SK TRANSPORT PLANNING

TECHNICAL NOTE

Project: Planning Application DC/26/0671 – Land off Old Crawley Road, Faygate – 120 Residential Units

10.0 PROBLEM LOCATION PLAN

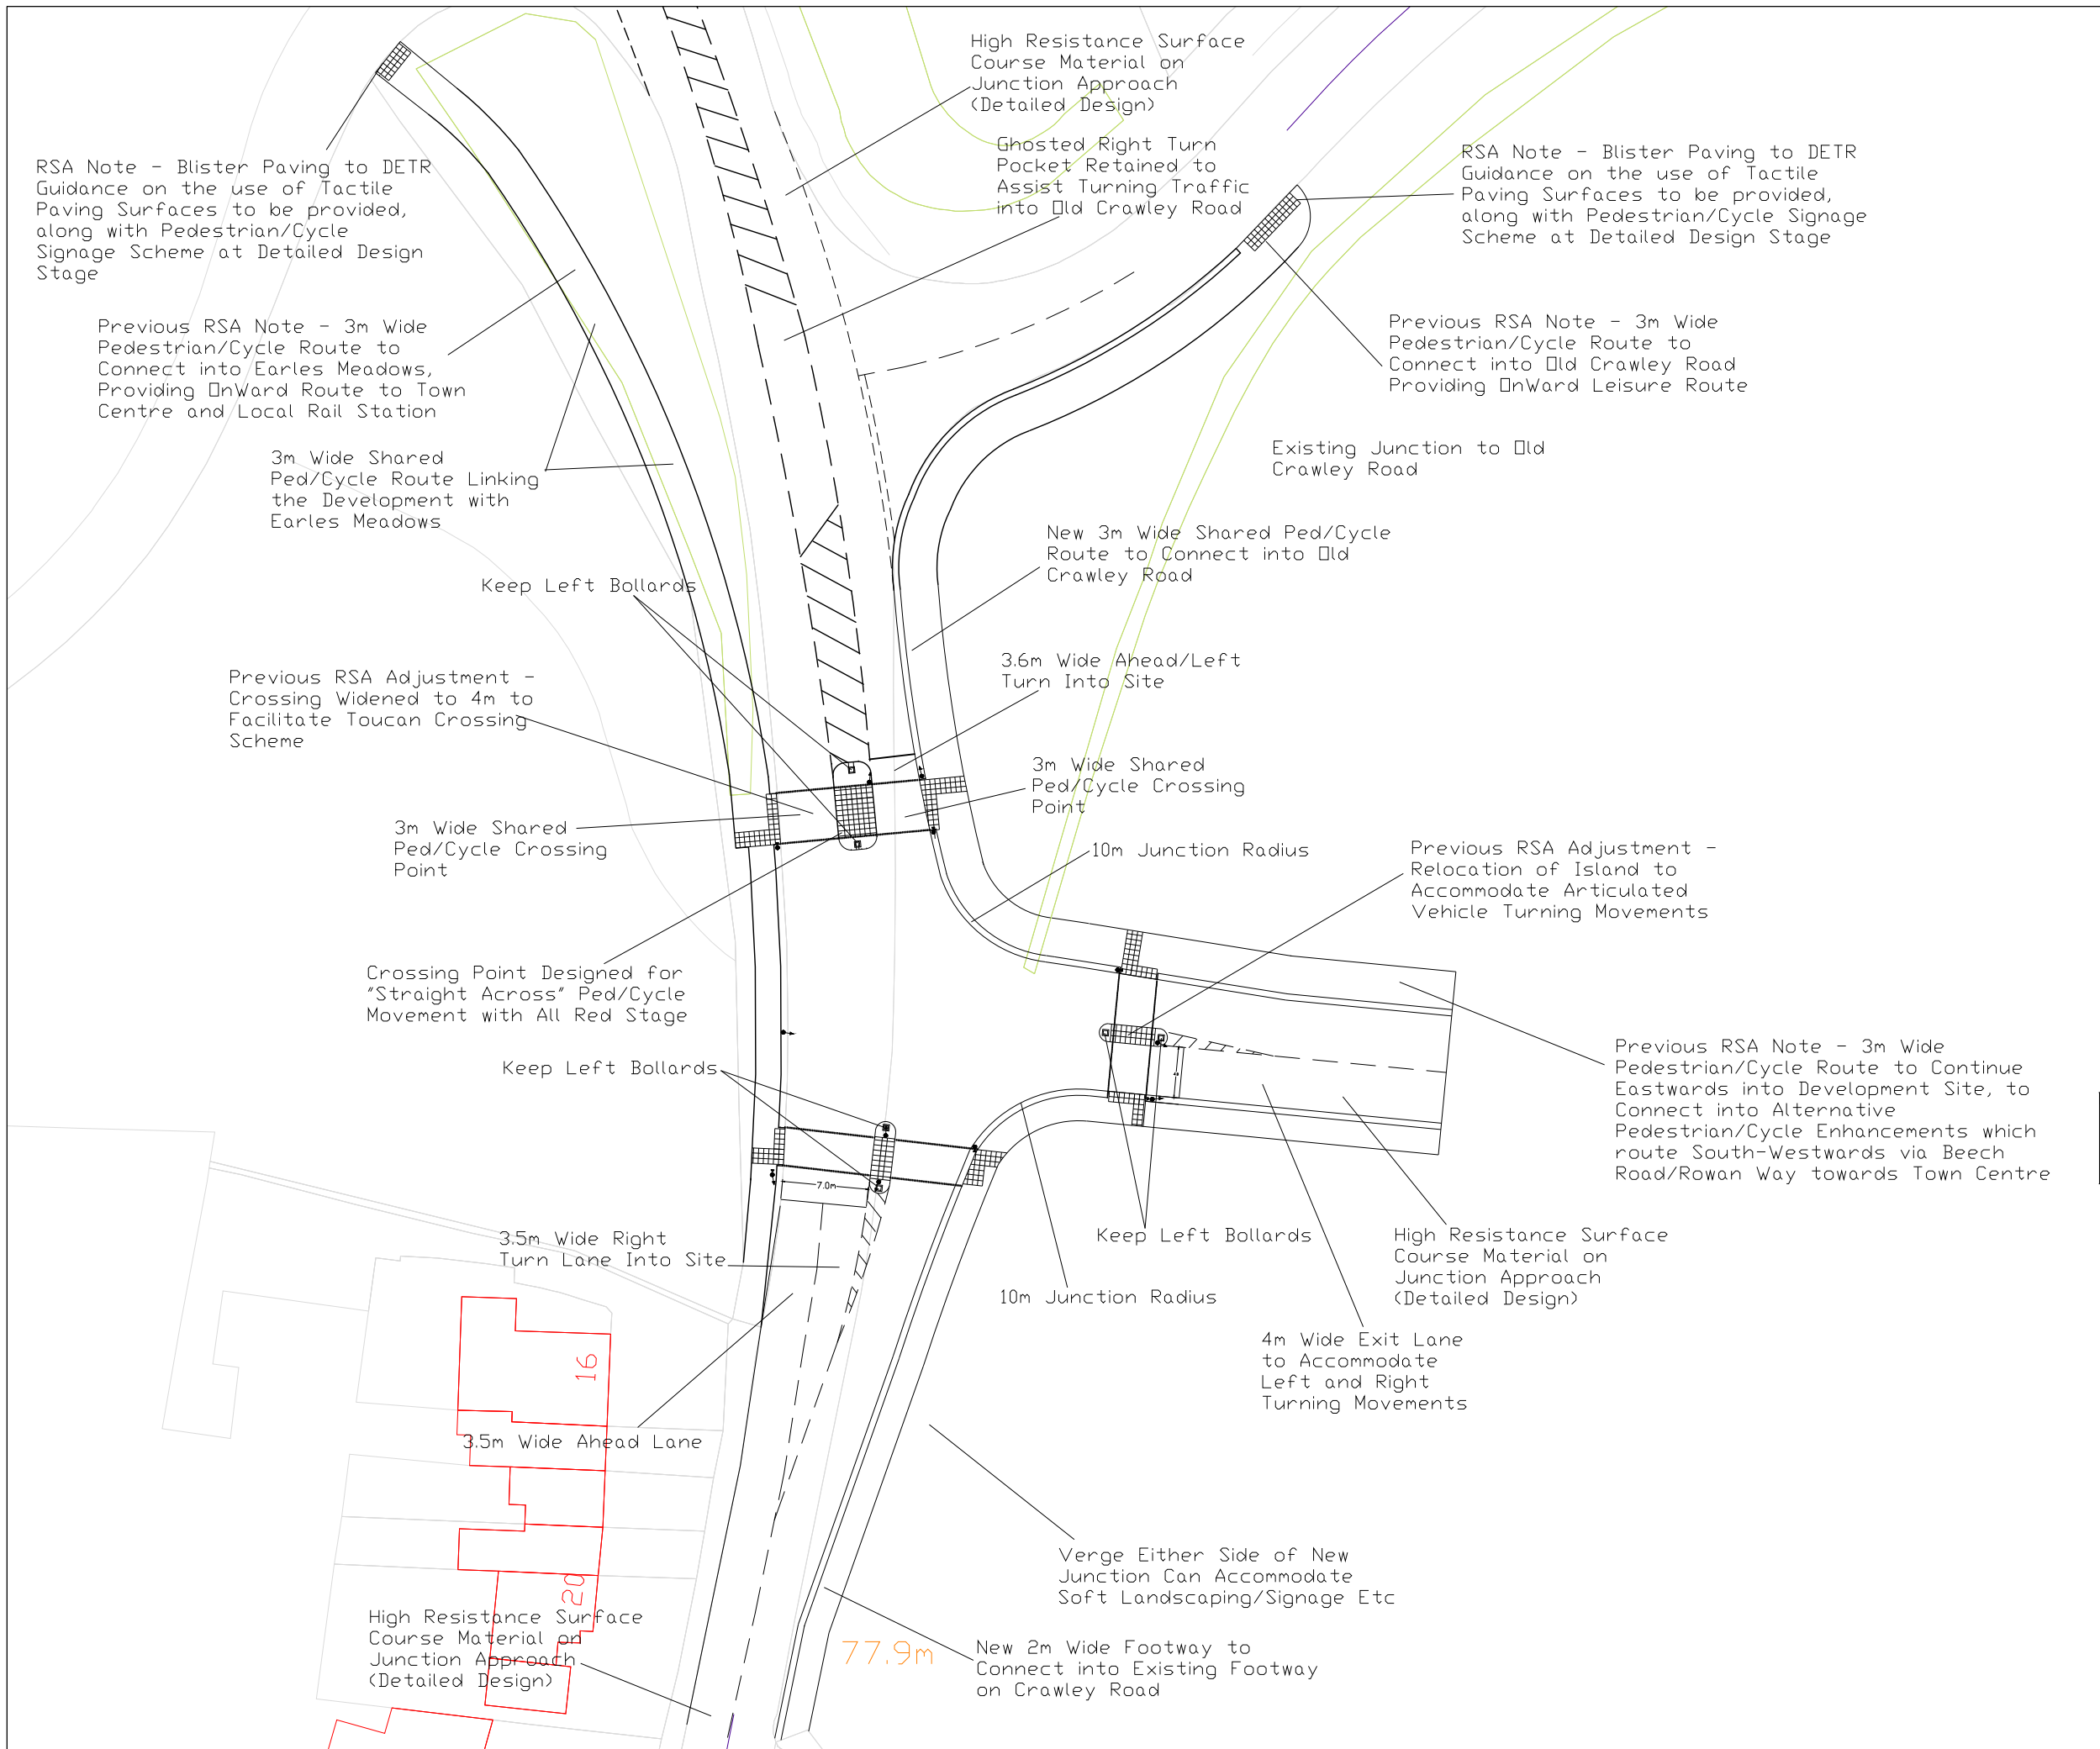
RSA Matter Number	RSA Problem	RSA Recommendation	Design Organisation Response	Overseeing Organisation Response	Agreed RSA Action
1	The RSA team have commented that they have a concern that any larger vehicles turning right into the development site access from Crawley Road (the southern junction arm) into the development site (the eastern arm) would encroach into the adjacent northbound traffic lane when undertaking this turning manoeuvre. The audit team has raised the concern that this could lead to a potential increased risk of side swipe type vehicle collisions occurring between larger vehicles turning right from the southern arm of Crawley Road and another large vehicle travelling northbound towards the A264 corridor.	The RSA team's recommendation is that a review of the lane widths is undertaken, and if needed the junction design modified to address this issue	In response to the RSA team's comments a check of the clear nearside lane width has been undertaken against the typical weekly large refuse vehicle manoeuvre to/from the residential development site. The exercise has confirmed that a large refuse vehicle will travel north on Crawley Road, and then turn into the dedicated right turn lane, to then turn right into the minor junction arm. As part of this manoeuvre it is possible that the turning vehicle may have to wait within the junction to make the right turn. A review of the width of the nearside "ahead" lane confirms that at the stop line if the refuse vehicle was making a right turn manoeuvre the useable nearside lane width would be 3.21m, increasing to 3.67m immediately to the north of the controlled crossing facility. This width increases to 4.95m at a point where the refuse vehicle is undertaking its right turn into the site. These measurements are shown on plan, and are considered to be a "worst case" assessment, with the refuse vehicle

RSA Matter Number	RSA Problem	RSA Recommendation	Design Organisation Response	Overseeing Organisation Response	Agreed RSA Action
			positioned 0.7m from the central junction refuge, when undertaking this manoeuvre.		
2	The RSA team have commented that the scheme proposes a new 3m wide shared use footway on the western side of Crawley Road, that connects with Earles Meadows, and a 3m wide shared use footway on the northern side of the development site access road, that connects to Old Crawley Road to the north. There are no existing footways in Earles Meadows or Old Crawley Road where the shared use footways are shown to end. The audit team has flagged that pedestrians and cyclists may be introduced back to the carriageway without any warning to motorists at this location, potentially leading to an increased risk of vehicular and pedestrian/cycle collisions occurring.	The recommendation is that appropriate tie-in details for the shared use footways should be clearly defined, to include how pedestrians and cyclists enter and exit these shared use facilities, in order to mitigate the above described potential collision scenario.	In response to the RSA team's comments it was always the intention that this additional level of detail at the Earles Meadow and Old Crawley Road tie in points would be delivered at detailed design stage. This would include confirmation of cycle signage and carriageway markings. To demonstrate that appropriate detail can be provided at both tie in points tactile blister paving has been added at this location, in line with the DETR Guidance on the use of Tactile Paving Surfaces document. Signage and additional markings complying with the Traffic Signs and General Directions Manual will be included in the detailed design package of works. Based on this review it is confirmed that an appropriate detail will be provided at both tie in points, to ensure the safe passage of pedestrians and cyclists at this location.

RSA Matter Number	RSA Problem	RSA Recommendation	Design Organisation Response	Overseeing Organisation Response	Agreed RSA Action
3	The RSA team have noted that General Arrangement drawings do not show “keep left” bollards on the traffic islands on all arms of the proposed signalised junction. As a result the lack of bollards could lead to a risk of kerb strikes and subsequent loss of control collisions occurring, leading to personal injury.	The RSA team’s recommendation is that “keep left” bollards are provided on the islands, in order to mitigate against the risk of kerb strikes/loss of control collisions.	In response to the RSA team’s comments it was expected that this level of design detail would be included at detailed design stage, but as part of the RSA process the location of keep left bollards have been shown on the traffic islands, as suggested.		
4	The RSA team have noted the presence of vegetation on the western and eastern sides of Crawley Road, to the east of Earles Meadow and Old Crawley Road. The concern is that without a regular maintenance programme, future re-growth of the vegetation could impact the forward visibility to the signal heads.	The RSA team’s recommendation is that this vegetation/growth needs to be kept clear in perpetuity to ensure that appropriate visibility is provided to all signal heads	In response to the RSA team’s comments SKTP drawing SK21905-04 REV C shows the forward visibility splay envelopes to the signal heads on the northbound and southbound approaches. They confirm that 120m of forward visibility can be achieved on both approaches. These visibility splays envelopes fall across land that forms part of the adopted highway, and so WSCC, as Highway Authority has an obligation to keep all vegetation/foliage clear of visibility splays/sightlines. If a financial contribution towards a maintenance programme/management plan is required then this will be considered.

RSA Matter Number	RSA Problem	RSA Recommendation	Design Organisation Response	Overseeing Organisation Response	Agreed RSA Action
5	The RSA team have commented that the lack of red tactile paving at the signalised crossing facilities could result in the blind or visually impaired pedestrians crossing Crawley Road at less suitable locations, which could lead to a potential increased risk of blind and visually impaired pedestrian collisions occurring. In addition, the lack of corduroy paving and suitable/adequate shared use/footway/cycleway signing could lead to a potential increased risk of cyclist and pedestrian collisions.	The recommendation is that suitable and adequate signing for the shared use footway/cycleway should be provided, as well as tactile paving and corduroy hazard paving, in accordance with DETR guidance.	In response to the RSA team's comments it was always the intention that this additional level of detail would be delivered at detailed design stage. This would include confirmation of signage, tactiles and any footway/cycleway markings. To demonstrate that appropriate tactiles will be provided at all crossing points these have been added at all locations, in line with the DETR Guidance on the use of Tactile Paving Surfaces document. These are shown on plan in appendix c. Signage and additional markings complying with the Traffic Signs and General Directions Manual will be included in the detailed design package of works.

6	The RSA team have commented that the scheme as presented does not provide an appropriately located maintenance lay-by/hard standing area, which in turn could result in operatives parking their vehicles in unsafe locations in the vicinity of the signal apparatus.	The recommendation is that a lay-by or hard standing area is provided in a safe location for an operative to access the signal apparatus. This space should be located clear of the traffic lanes, signal poles, heads etc.	In response to the RSA team's comments with the internal development layout being presented as an illustrative scheme, it will be possible to incorporate a parallel parking/service bay on the southern side of the development arm of the junction, close to the junction but outside of all visibility splays and junction equipment. The need for this bay has been noted on the updated drawing, provided in appendix c, and will be incorporated at detailed design stage.

RSA Matter Number	RSA Problem	RSA Recommendation	Design Organisation Response	Overseeing Organisation Response	Agreed RSA Action
	The concern is that this could lead to the increased risk of vehicular and site operative collisions, or potentially an increase in vehicle/vehicle collisions due to motorists attempting to avoid inappropriately parked maintenance vehicles.				
7	The RSA team have commented that the introduction of new stop lines with the signalised junction will create new braking areas on all approaches. The audit team has highlighted that unexpected or late braking could lead to the potential increased risk of vehicular and pedestrian/pedal cyclist collisions occurring, which in turn could lead to personal injuries.	The RSA recommendation is that high resistant surface course material (formally known as the wearing course) should be provided on all approaches, and as a minimum the length of this skid resistant wearing course should reflect the approach speeds and minimum stopping sight distances expected at this location.	In response to the RSA team's comments the use of high resistant surface course material is fully supported, and will be specified as part of the detailed junction design on all approaches. As a starting point, as shown on drawing SK21905-04 REV C, 120m forward visibility envelopes to all signal heads have been shown. The use of high resistant surface course material could also cover the extents of these envelopes, to ensure that all users of the highway have the ability to slow on the junction approaches. The requirement for the detailed design to incorporate high resistance surfacing has been notated on the scheme drawing provided in appendix c.

RSA Matter Number	RSA Problem	RSA Recommendation	Design Organisation Response	Overseeing Organisation Response	Agreed RSA Action
8	The RSA team has already commented under RSA Matter 4 that the site visit confirmed that there is the presence of vegetation on the eastern and western sides of Crawley Road. This final RSA matter also brings into the review the potential for this vegetation, and any new street furniture/landscaping to interfere with the intervisibility on all junction approaches. The visibility splay envelopes are shown on drawing SK21905-04 REV C.	The recommendation is that the intervisibility zones on all approaches should be kept clear of any impediments, in order to mitigate the risk of reduced visibility and potential collisions as a result.	As set out in RSA Matter 4, as part of the detailed design work, and as shown on SKTP drawing SK21905-04 REV C, the forward visibility splay envelopes to the signal heads on the northbound and southbound approaches fall across land that forms part of the adopted highway, and so WSCC, as Highway Authority has an obligation to keep all vegetation/foilage clear of visibility splays/sightlines. As part of the detailed design works, any physical infrastructure/existing street furniture will also be reviewed/assessed to ensure all forward visibility requirements and envelopes are maintained in perpetuity. If a financial contribution towards a maintenance programme/management plan is required then this will be considered.

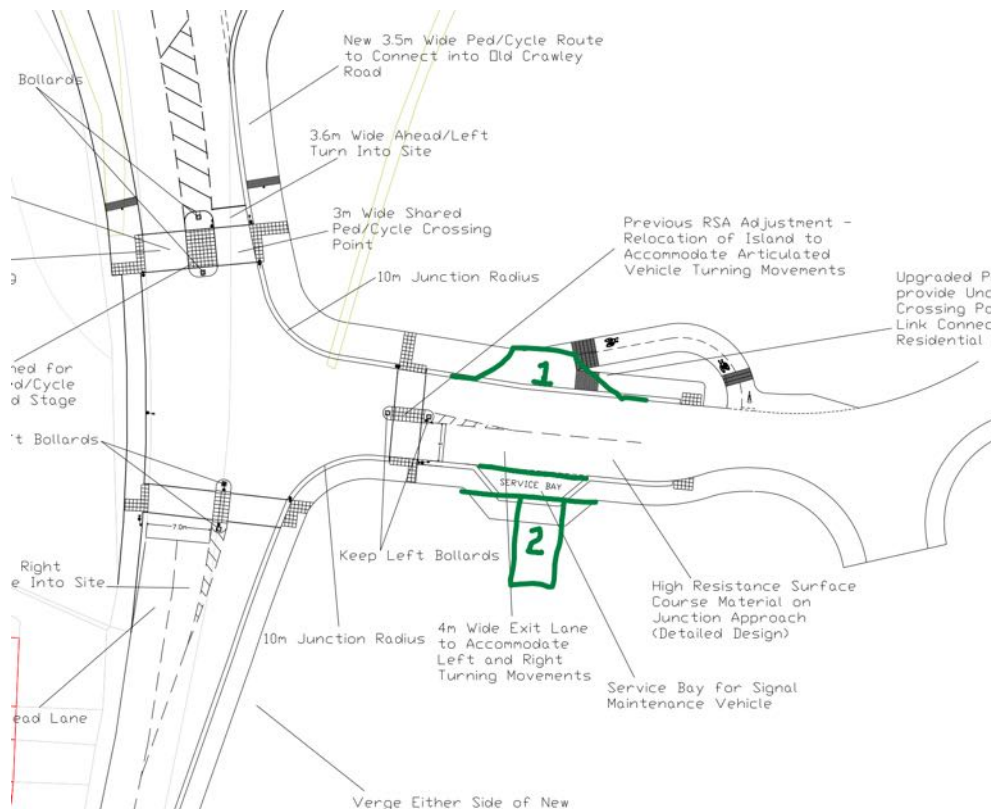
We also had a query regarding the location of the signal servicing bay, which Adam had requested be relocated. Would you be in a position to comment on this too please, in the hope that location 1 (sketched on the plan earlier in this email trail) is acceptable.

Thanks for the email on Friday Jamie, and also for inputting into the LinSlg and signal service bay Adam. Very helpful, and we've been looking at this this morning.
